230612 NPC-JC Consultation Response [R3.0138-21]

**STATEMENT OF OBJECTION – PLANNING APPLICATION [R3.0138/21]  
HIF1 Road between A34 Milton Interchange & B4015 north of Clifton Hampden  
REVIEW OF THE ENVIRONMENTAL STATEMENT - DATED APRIL 2023**

Figure 1 plan illustration of alternative position (in red) for HIF1 road and bridge crossing Appleford rail sidings.

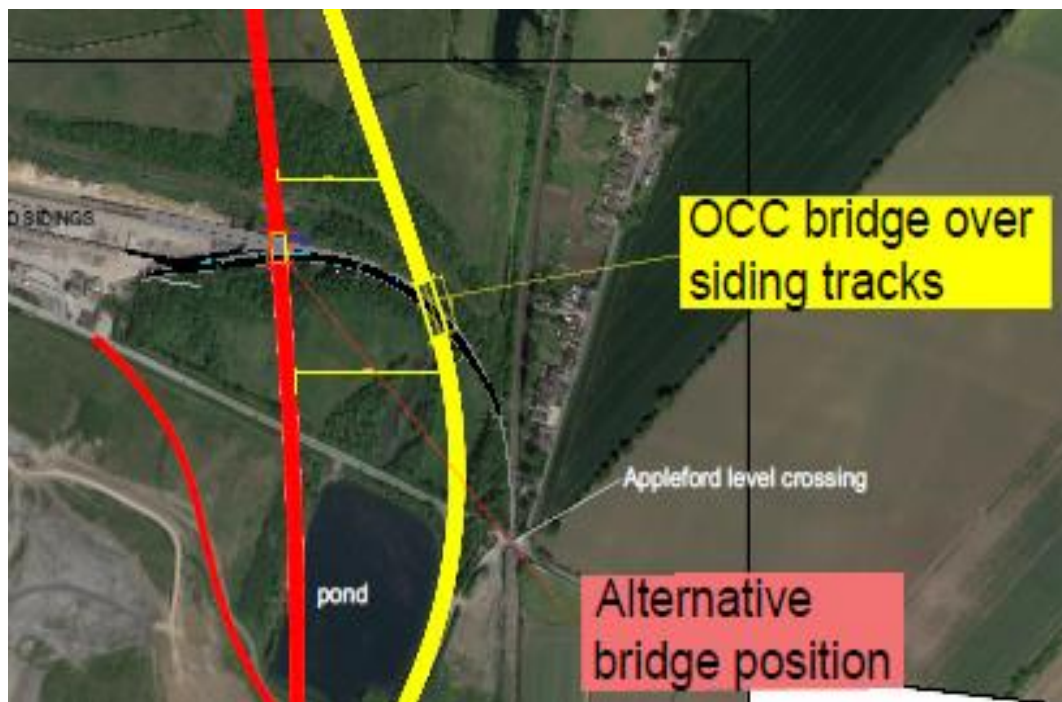
- 6.8 The planning team of the Vale of White Horse DC state that due to the fact that “residents of affected dwellings will experience significant adverse effects despite acoustic barriers” and “the visually intrusive appearance of the acoustic barriers, consideration should be given to moving the road further west.”

- 6.9 A viable alternative road alignment further west, for the road and bridge over Appleford Sidings is available, see figure 1. This alignment would not require a skewed bridge design which would result in a more efficient smaller bridge structure. The road’s further distance away from dwellings in Appleford would reduce the noise impact and provide the offset distance for other landscape-based noise attenuation. A comparison of noise environment of both alignments need to be undertaken to allow a selection of the route alignment that minimises the noise impact on nearby dwellings.
